DEPARTMENT OF TRANSPORTATION

Airworthiness Directives; Eurocopter France Model AS350B, B1, B2, B3, BA, C, D, D1, and AS355E, F, F1, F2, and N Helicopters

ACTION: Notice of proposed rulemaking

Figure 2. Play Measurement on Tail Rotor Pitch Control Rod

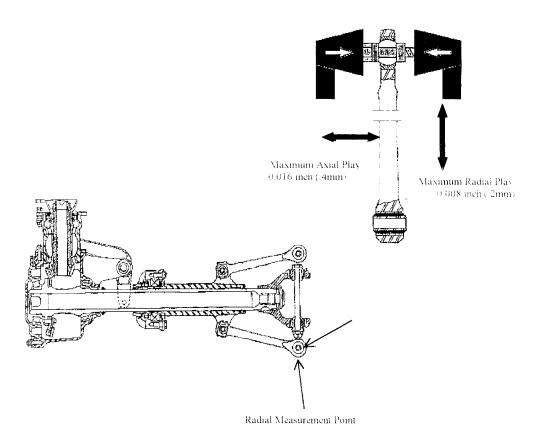
- (2) If play is detected, measure the bearing wear using a dial indicator as shown in Figure 2. Perform the following steps (Figure 2) unless they were accomplished within the last 30 hours TIS.

- (i) Remove the control rod.
- (ii) Install a bolt, washers, and a nut to secure the bearing.
- (iii) Mount the bearing in a vise as shown in Figure 2.

- (iv) Using a dial indicator, take two radial measurements in the areas shown by the two arrows
- (v) Take axial measurements in the area shown by an arrow.

- (vi) Record the hours of operation on each control rod.
- (vii) If the radial play exceeds 0.008 inch or axial play exceeds 0.016 inch, replace the
- control rod with an airworthy control rod before further flight.

- (3) If the radial and axial play are within limits, reinstall the control rod.
- (4) At intervals not to exceed 30 hours TIS, remove the control rod and measure the bearing wear with a dial indicator (Figure 2) using steps (a)(2)(i) through (a)(2)(vii).
